Access Compliance Report

Public Rights-of-Way

(Curb Ramps)

Intersection ID: 11538	Main Street: FREEDOM_DR	Cross Street: BERRYHILL_RD	Location: E
ADA ID: 125959C1F10B	Ramp Type: Perp	Initial Pass/Fail: Fail	Overall Compliance: No
Severity Score: 22.5			
Codes/Mitigation Info/Possible Solution		Field Measurements/Component Compliance

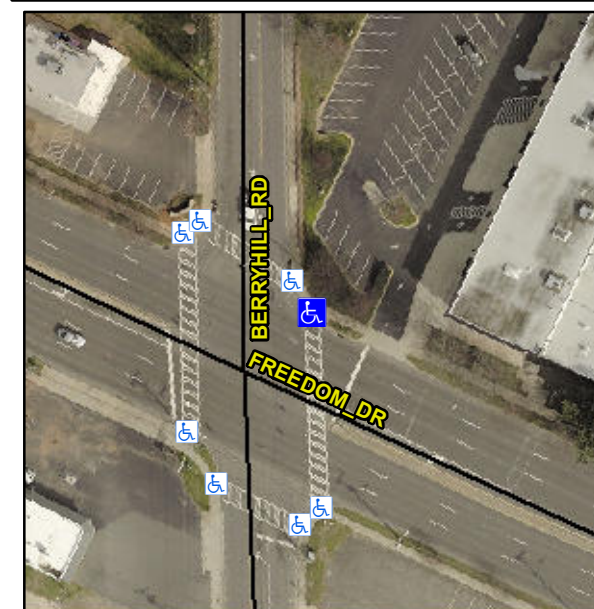
R304.5.1, R304.2.2

Compliance	Description	Data	Compliance	Description	Data
N/A	Ramp Length (in)	76.5	No	Ramp Slope (%)	8.4
No	Ramp Width (in)	47.0	Yes	Ramp XSlope (%)	4.2
N/A	Flare Type LT	N/A	N/A	Flare Type RT	N/A
N/A	Flare Slope LT (%)	N/A	N/A	Flare Slope RT (%)	N/A
N/A	Flare Traversable LT?	N/A	N/A	Flare Traversable RT?	N/A
N/A	Landing Length (in)	N/A	N/A	DWS Provided?	N/A
N/A	Landing Width (in)	N/A	N/A	DWS Contrast?	N/A
N/A	Landing Slope (%)	N/A	N/A	DWS Length (in)	N/A
N/A	Landing X Slope (%)	N/A	N/A	DWS Full Width?	N/A
N/A	Landing Curb? (Y/N)	N/A	N/A	DWS Offset (in)	N/A
N/A	Shared Landing?	N/A			
N/A	Gutter Ponding?	N/A	N/A	Gutter Slope (%)	N/A
N/A	Gutter Lip Ht (in)	N/A	N/A	Gutter X Slope (%)	N/A
N/A	Painted X Walk1?	Yes	N/A	Painted X Walk2?	N/A
	X Walk 1 Direction	To S		X Walk 2 Direction	N/A
N/A	X Walk 1 Width (in)	105.0	N/A	X Walk 2 Width (in)	N/A
	X Walk 1 Slope (%)	2.5		X Walk 2 Slope (%)	N/A
	X Walk 1 X Slope (%)	5.0		X Walk 2 X Slope (%)	N/A

Remove & Replace Entire Ramp.
